**Proposed Temporary Open Storage of Vehicle with Ancillary Facilities
for a Period of 3 Years and Associated Filling of Land and Pond in "Recreation" Zone,
Various Lots in D.D. 126 and Adjoining Government Land, Ping Shan, Yuen Long, New Territories**

(S.16 Planning Application No. A/YL-PS/739)

Responses-to-Comments

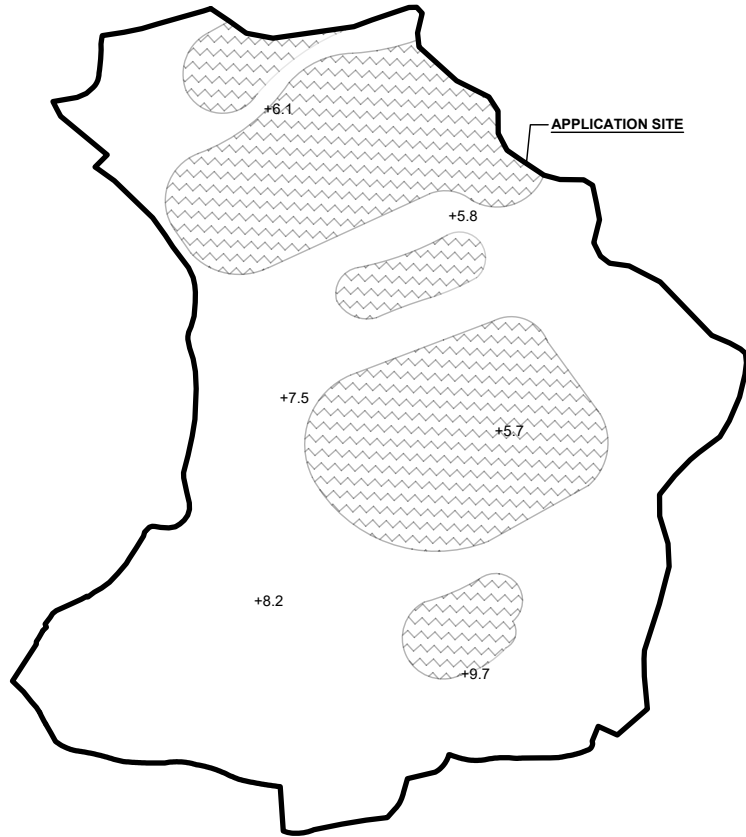
(b)	Given the temporary nature and the proposed use as open storage of the subject site, the requirement for NTHS might make the case not economically viable. As an alternative, part of the subject site (as indicated in Annex 2) maybe designated as a “no-build” zone, within which no critical facilities (i.e. facilities under Groups 1 to 3 in Annex 3) should be located. In particular, the proposed site offices should be located away from the “no-build” zone. With the inclusion of the “no-build” zone, the requirement for NTHS may be waived.	<u>No critical facilities</u> will be located within the “no-build” zone. The proposed structure, i.e. a guardroom, is located about 30 m away from the boundary of the “no-build” zone. Besides, no manned facilities nor open storage of dangerous goods will be allowed within the “no-build” zone. As such, it is considered that the requirement for Natural Terrain Hazard Study would not be necessary. Please refer to the Layout Plan at Plan 1 of Annex 1.

LANDSCAPE PLAN

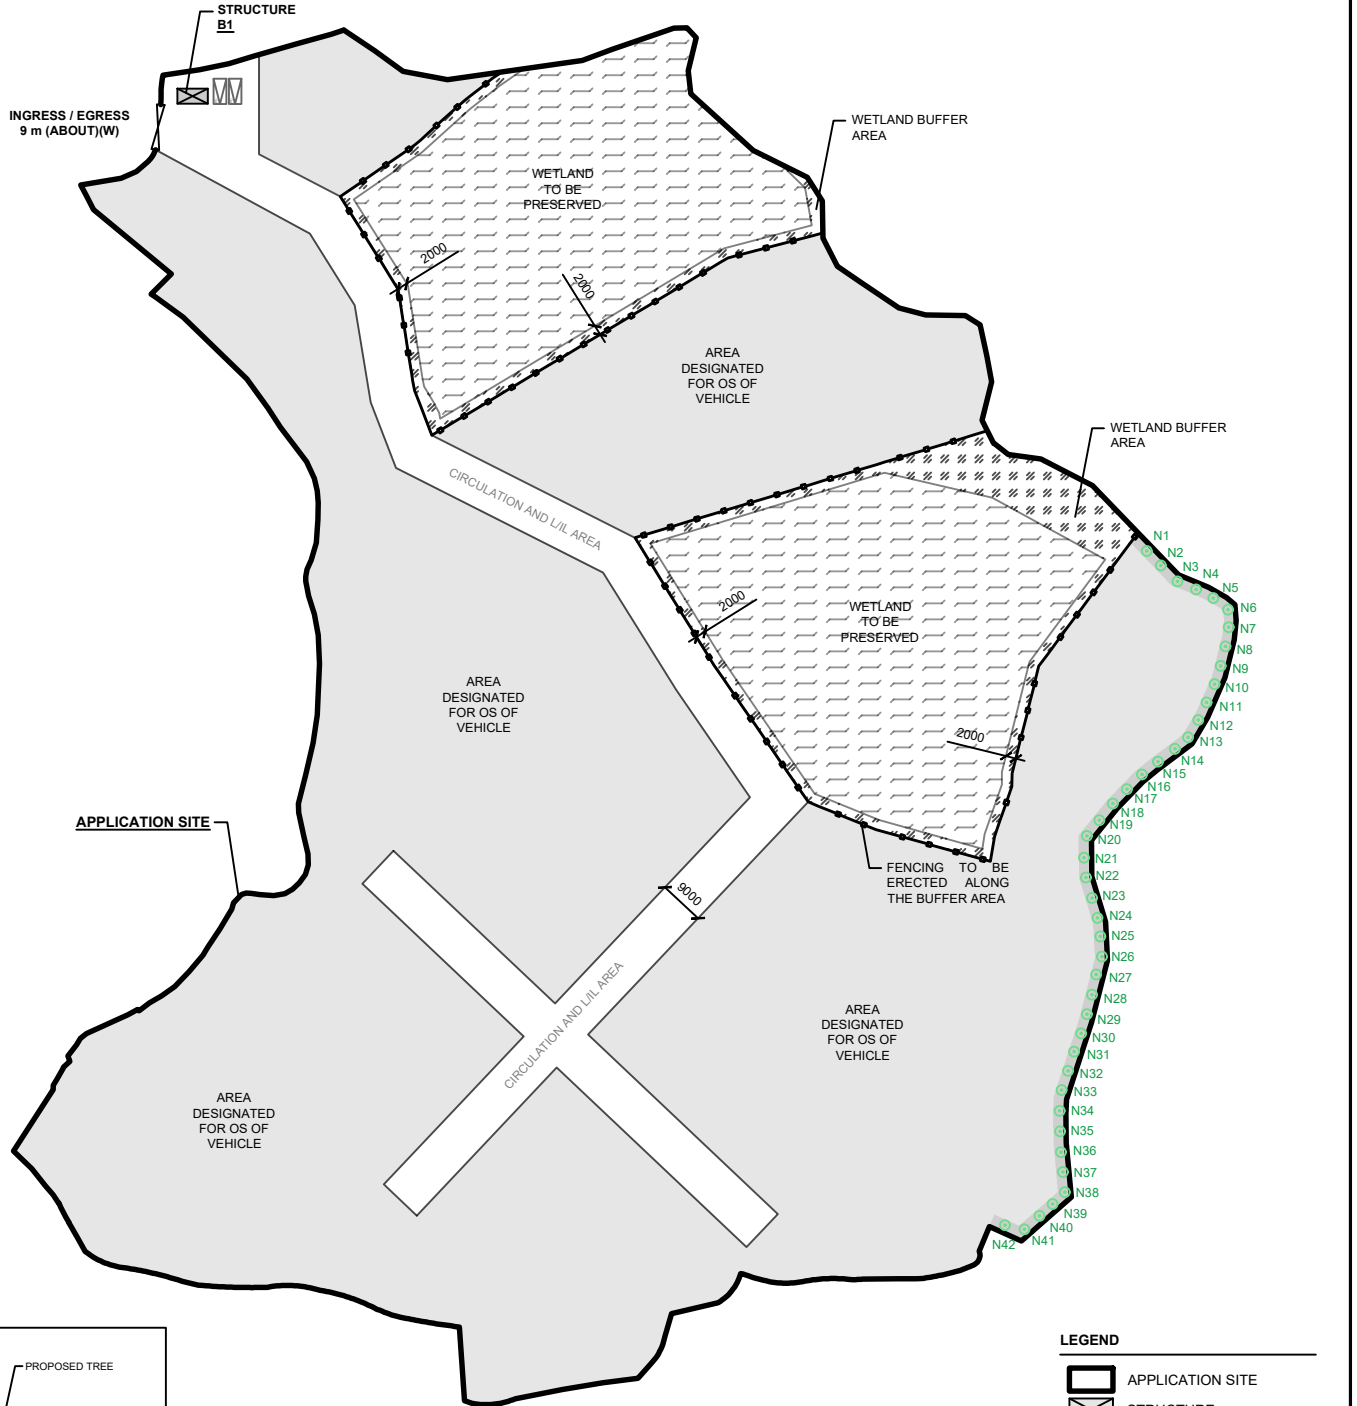
Departmental Comments		Applicant's Responses
5. Comments of the Chief Town Planner/Urban Design and Landscape, Planning Department (CTP/UD&L, PlanD)		
(a)	No landscape technical assessment such as information of existing landscape resources and proposed mitigation measures are included. The Applicant should provide the broadbrush tree survey, mitigation measures and landscape proposal to demonstrate that the proposed uses would not have adverse landscape impact on the Site and surrounding areas.	The applicant proposes to <u>plant 42 nos. of new trees</u> of local species along the eastern periphery of the Site, with a view to mitigating the potential adverse landscape impact that would have arisen from the proposed development. The Landscape Plan is enclosed at Plan 1 of Annex 2 .
